SERVICE BULLETIN

MODIFICATIONS OF THE OVERFLOW BOTTLE FOR ROTAX® ENGINE TYPE 912 AND 914 (SERIES)

SB-912-039

SB-914-025

(see fig. 1)

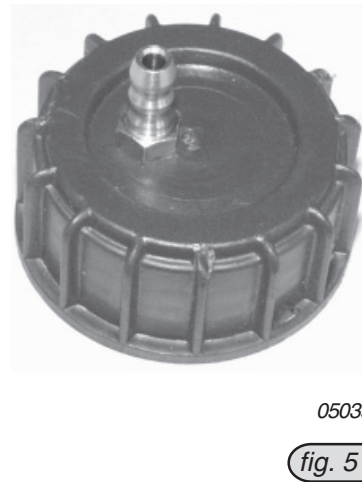
- Bore the existing vent hole from dia. 1mm (0.04 in.) to dia. 2.5mm (0.1 in.)
- Screw the cap onto the overflow bottle.

(see fig. 2 to 5)

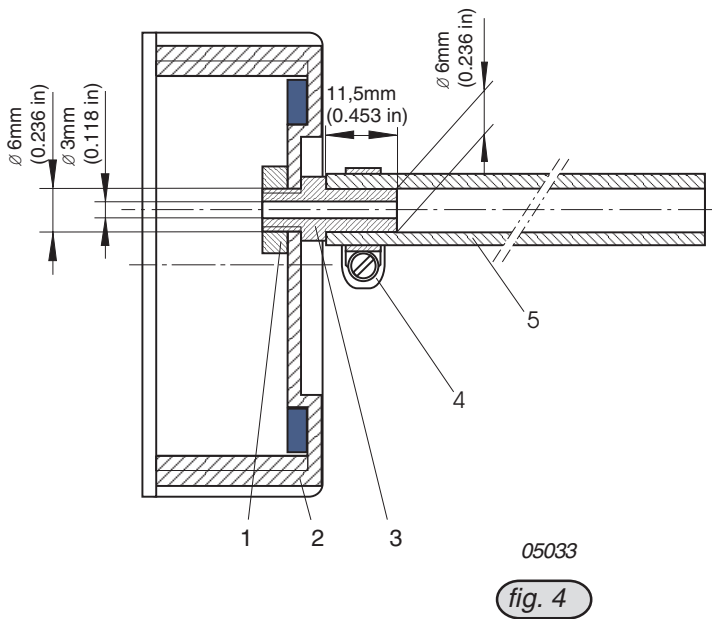
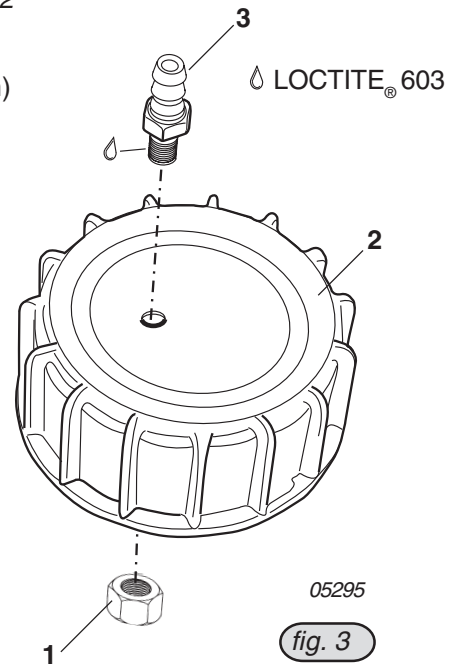
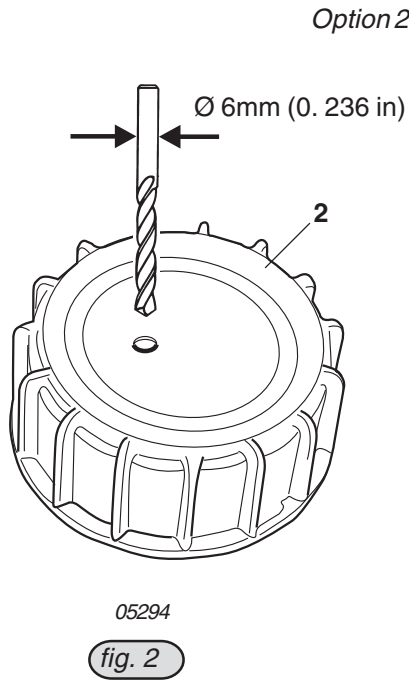
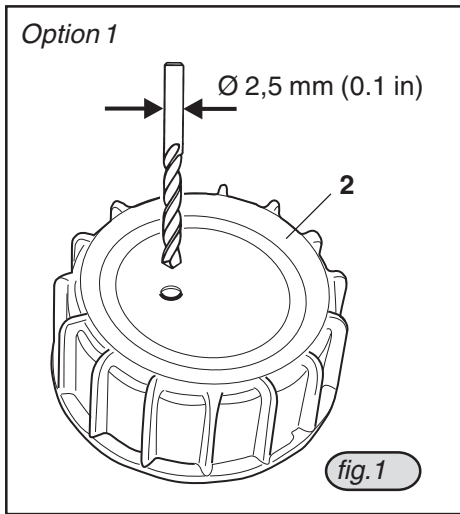
- Bore the existing vent hole from dia. 1mm (0.04 in.) to dia. 6mm (0.236 in.)
- Apply LOCTITE[®] 603 to the threads of the hose nipple (3).
- Insert nipple (3) into the vent hole.
- Install nut (1) onto the hose nipple (3). Tightening torque 5 Nm (44 in lb).
- Screw the cap onto the overflow bottle.

- Attach the hose with a gear-type hose clamp (4).
- Make sure the hose (5) has no kinks. Route it overboard and secure.
- Restore aircraft to original operating configuration.
- Connect negative terminal of aircraft battery.
